ITEM 3. DEVELOPMENT APPLICATION: HAROLD PARK - 10 MAXWELL ROAD - 72 AND 74 ROSS STREET - 1A AND 1B THE CRESCENT - FOREST LODGE - STAGE 2 - PRECINCT 2

FILE NO: D/2011/1312

Summary: Stage 2 DA for Precinct 2 including two residential buildings (8 storeys); 184 units; 166 car spaces and two pocket parks.

Figure 18 – The hatching shows where buildings are proposed to maintain the 1.25m lower level setback only and not be set back 3m.

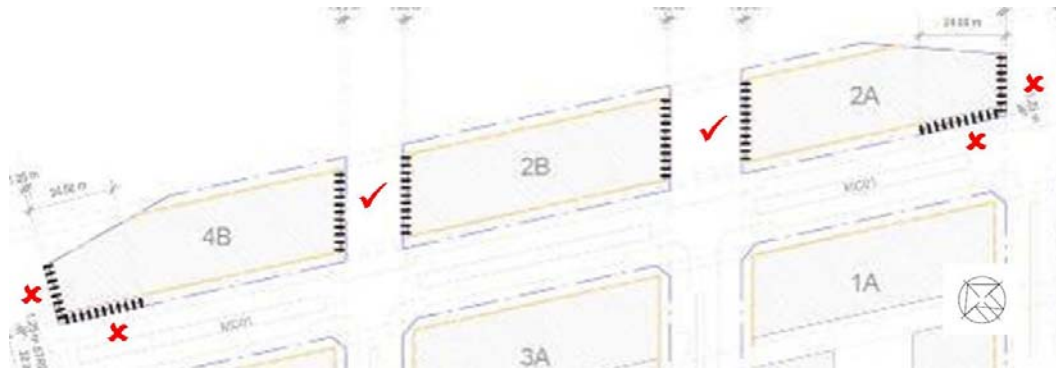
47. The Stage 1 DA required modifications to provide mid level setbacks to the south and west of Building 2A. **Figure 18** below shows where variations to mid level setbacks were supported (ticks) and where modifications were required to provide 3m setbacks instead of the 1.25m proposed (crosses).

48. Reduced setbacks in these locations were not supported at Stage 1 having regard to the reduced setbacks already proposed between the buildings (to the 'pocket parks') and because it was considered that further encroachments into the setback zones would potentially diminish the overall effectiveness of the mid level setbacks proposed along the rest of the building's frontages and the reduction in bulk that is achieved by those setbacks. The Stage 1 DA did make provision for the consideration of reduced setbacks with detailed Stage 2 DAs.

Figure 20 – Locations where upper level setbacks were required by the Stage 1 DA.

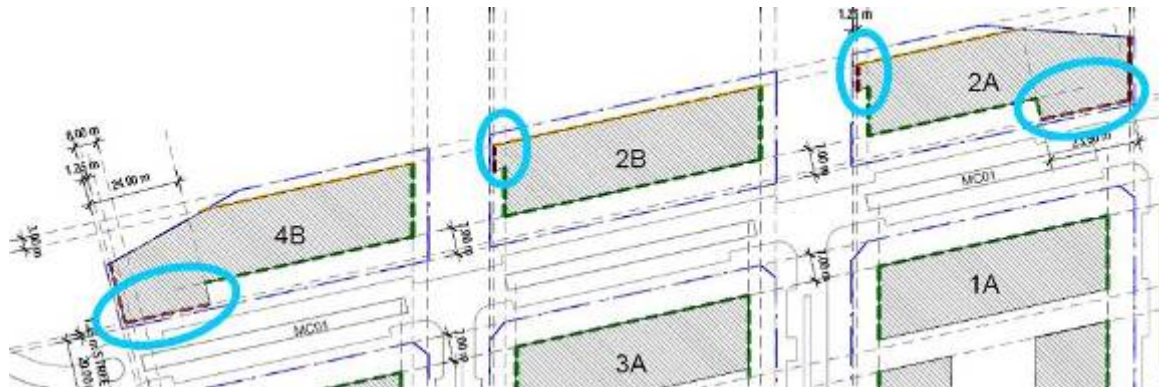
52. The Stage 1 DA required modifications to provide upper level setbacks in the locations shown below at **Figure 20**, as follows (measured from the property boundary):

- (a) Building 2A - north elevation (5.25m) and west elevation (7m); and
- (b) Building 2B - north and south elevation (5.25m).

Figure 21 – Building 2A – Level 7 - encroachment into northern setback area shown dashed.

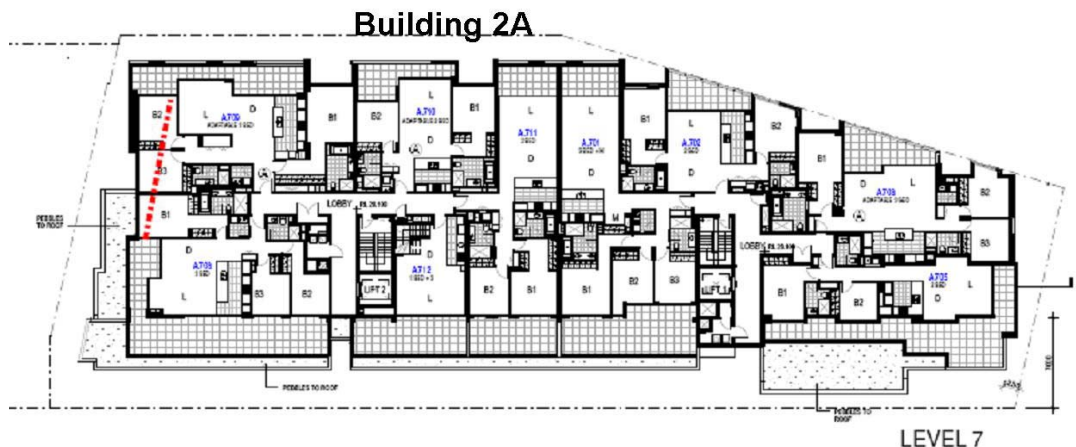
- (a) Northern elevation of 2A and 2B (level 7) – between 1.8m and 6.8m
- (b) Northern elevation of 2A and 2B (level 8) – between 3m and 6.8m
- (c) Western elevation of 2A – amended to comply to provide 7m setback
- (d) Southern elevation of 2B (levels 7 and 8) – 4m

54. The proposed encroachment of the 5.25m required setback along the northern ‘pop-out’ sections of Buildings 2A and 2B and the southern elevation of Building 2B is shown dashed below in **Figures 21 to 24**. Given the splayed elevations, the encroachments in these corners will not be highly perceptible from the west looking towards the future park. The encroachments are considered relatively minor and are acceptable.

Figure 29 – Proposed side fences to pocket parks.

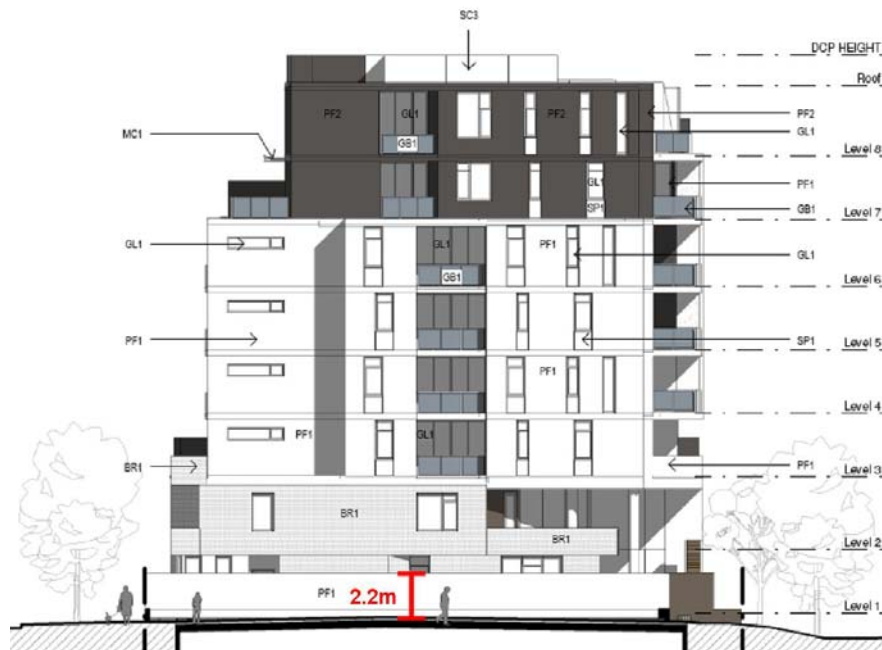
64. The parkside elevations have been designed to provide entries from the public open space. Front fences to the public open space and side fences to the pocket parks are around 2.1m high and of masonry construction. Refer to **Figures 28 and 29** below.

65. Under the DCP, front and side fences are not to exceed:
- (a) 900mm for masonry fences; and
 - (b) 1200mm for open/transparent fences with posts/piers of 1500mm.
66. The height of the front (parkside) and side (pocket parks) fences exceeds the permitted DCP heights, as shown in the figures above. At the parkside elevations, the fences are considered acceptable as they are a result of the floor levels of the terraces being set about 1m above the adjoining future park, which is permitted by the DCP. At the pocket parks, as the DCP allows higher side fences for corner buildings if required for safety and security, the higher fences are also acceptable.
